ADDENDUM NO.: 2

Description: Baruch College Furnish, Deliver and Install AV Equipment

Project: 3592009999

Specifics of the Addendum: Amend the Bid Opening Due Date and respond to questions received during the Request for Information period.

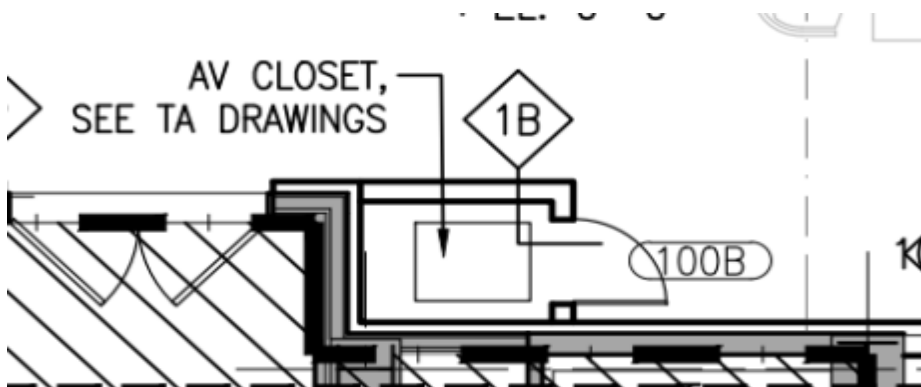
Q40. Does the server depth provide enough space for the BiAmp server?

A40. Response: Yes.

TA-600.00

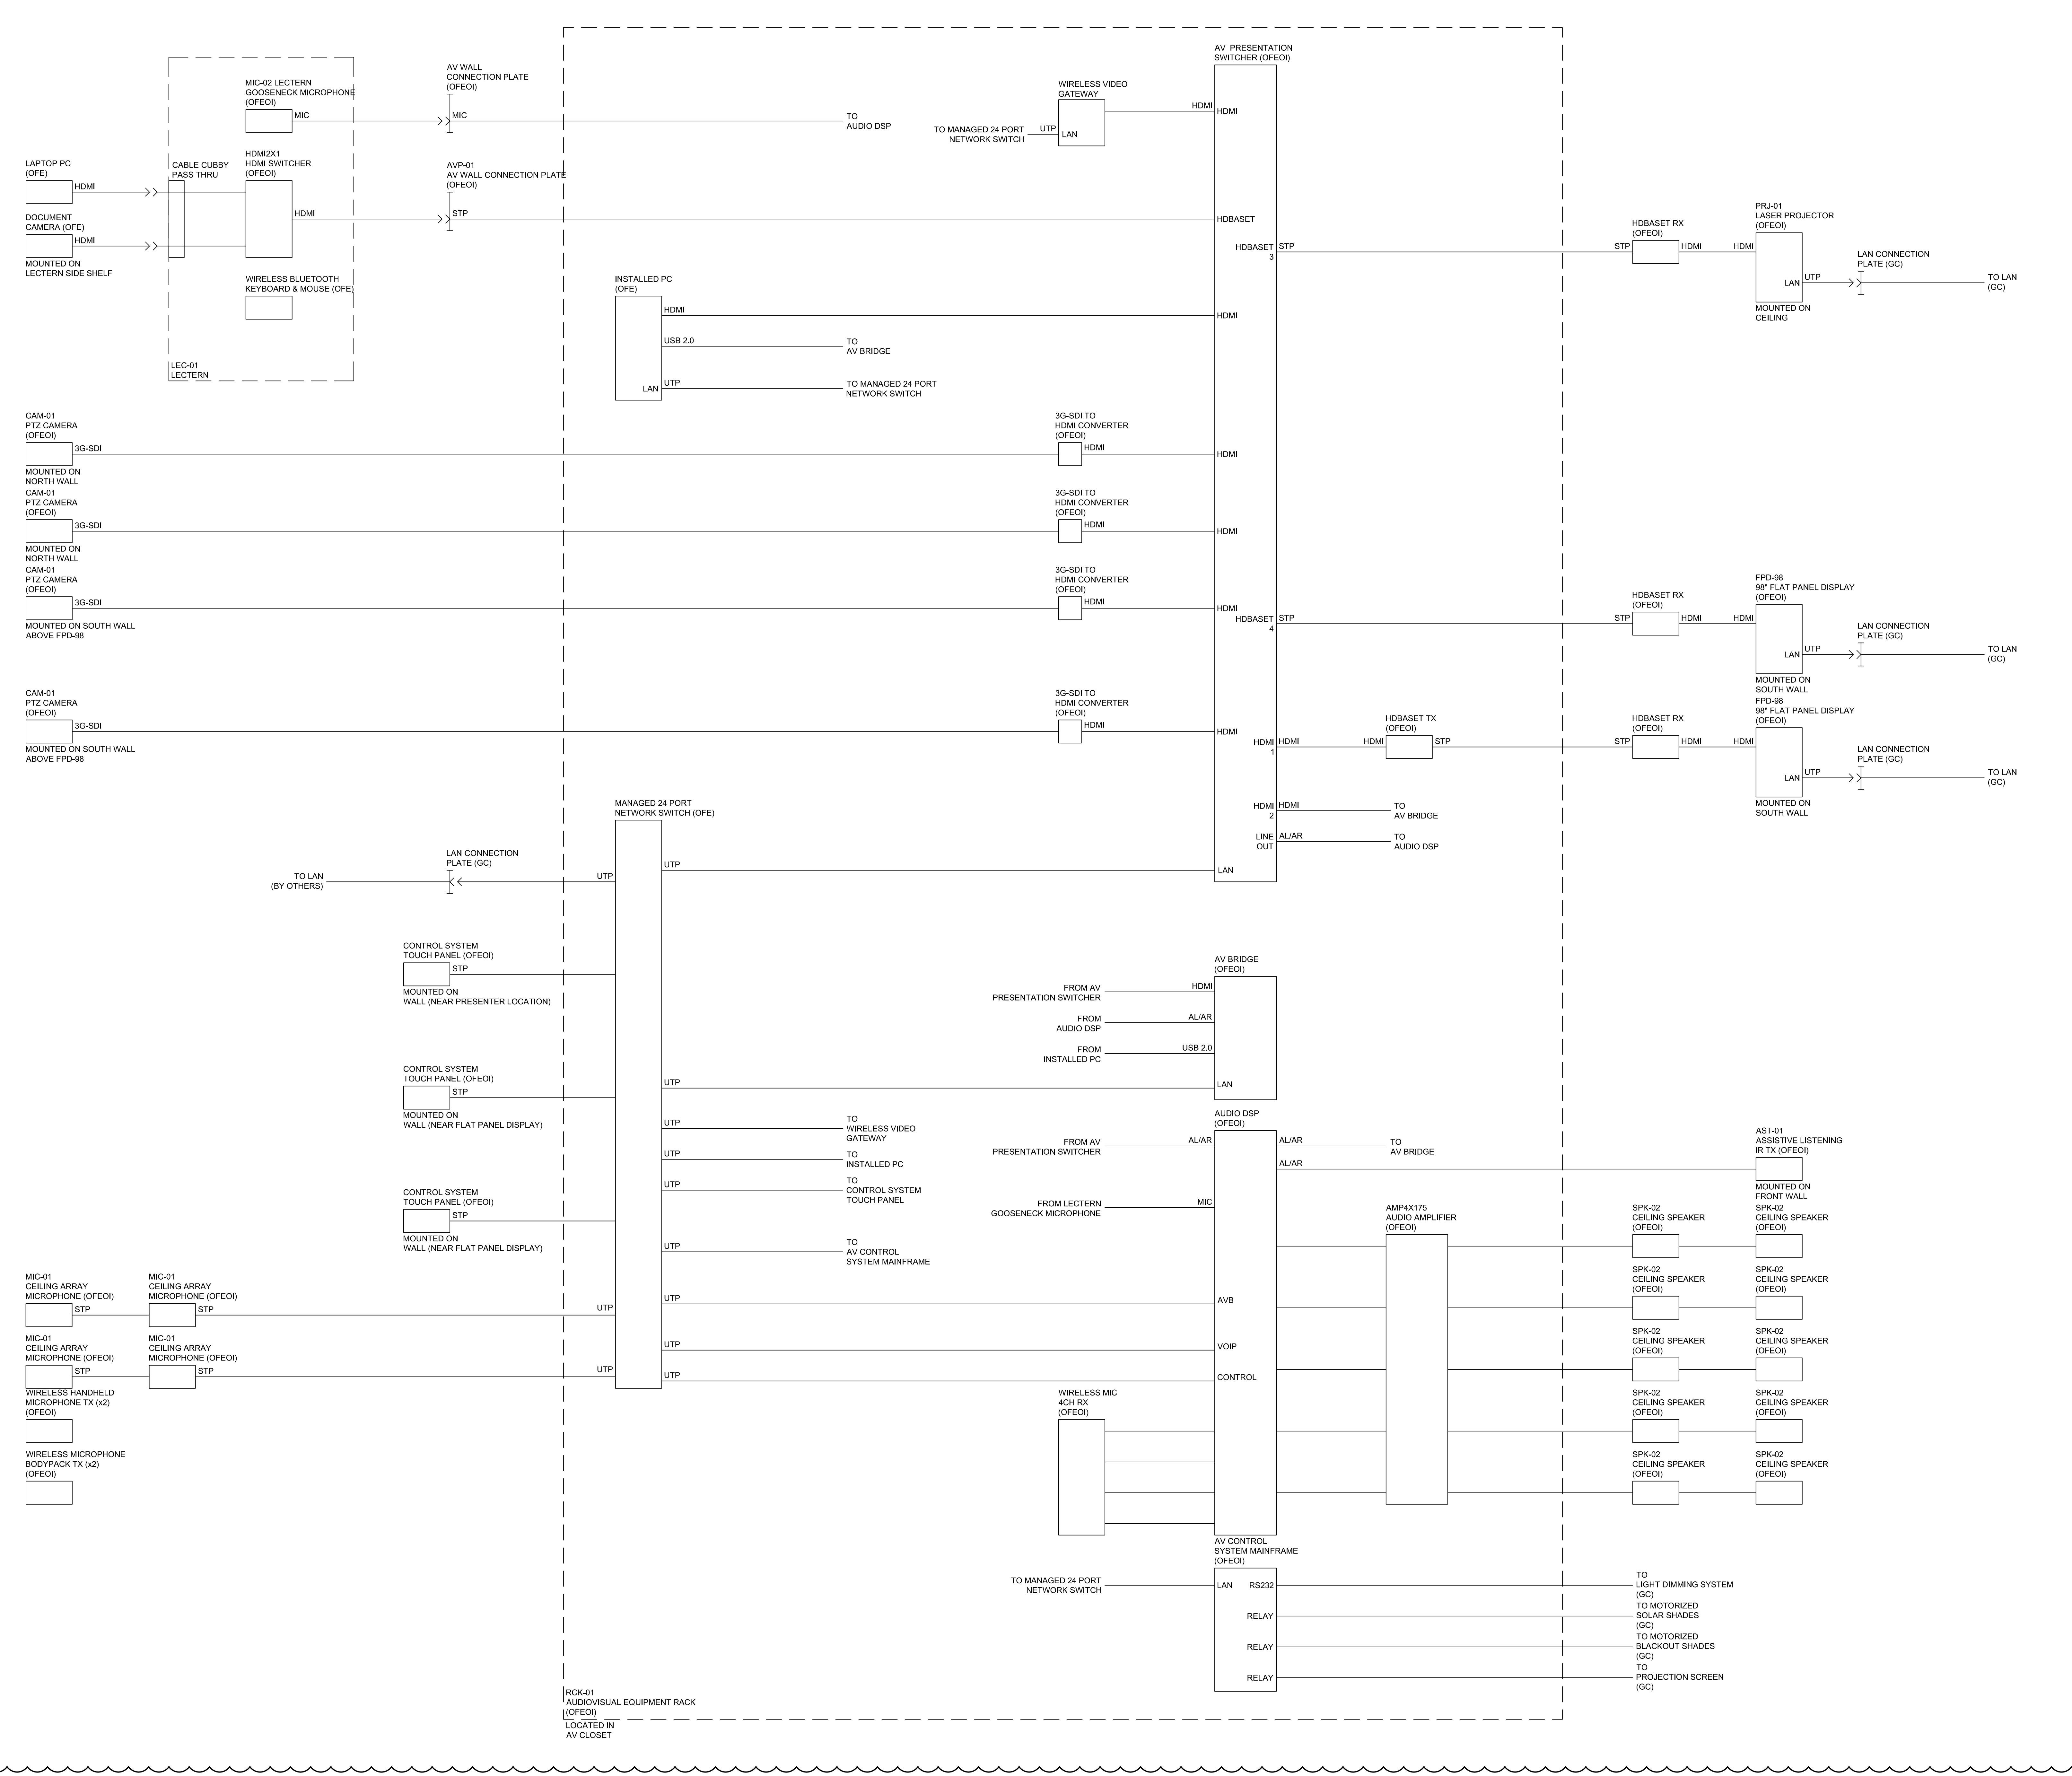
- A2. Response:**
- 1. Listen Technologies Quote #Q-21981.**
 - 2. Middle Atlantic Lectern #L2LDC2FCMGE.**
- Q3. There is a gooseneck microphone, Document camera & HDBASET TX (in the audiovisual equipment rack) exists in the SLD (Drawing no. TA-600) not mentioned in the equipment list.

- 3. HDBaseT Transmitter – Change to HDMI Switcher (Crestron HD-MD2X1-8K). See updated drawing TA-600.**
- Q4. The Crestron (DM-TX-4KZ-100-C-1G) is Transmitter 1 gang wall plate with 1 HDMI input but in the SLD (Drawing no. TA-600) it has two which is not applicable with the part number mentioned. Please advise.

Q5. In the equipment list, there is 2 amplifiers (Biamp Tesira AMP-8175R) but in the SLD (Drawing no. TA-600) only one exists. Please advise.

Q21. On Drawings TA-600 - Please provide the manufacturer and models for the; Light Dimming System, Solar Shades & Blackout shades that require AV control.

- A3. Response: See updated AV equipment list.**
- 1. Gooseneck Microphone 18" Gooseneck, supercardiod w/bottom LED & preamp – Shure 18" MX418/2.**
 - 2. Document Camera – Will be OFE, shown for reference only, (NIC).**

- A4. Response: Change HDBaseT TX in Lectern to HDMI Switcher (Crestron HD-MD2X1-8K). See updated drawing TA-600. See updated AV equipment list.**

A5. Response: Change to (1) Biamp Tesira AMP-4175R. See updated AV equipment list.

A21. Response: Refer to Specification Section 260922 – Lighting Fixture Controls for Light Dimming System and for Solar Shades and Section 122413 - Blackout Shades. This work is for reference only. Light dimming and shades are NIC.
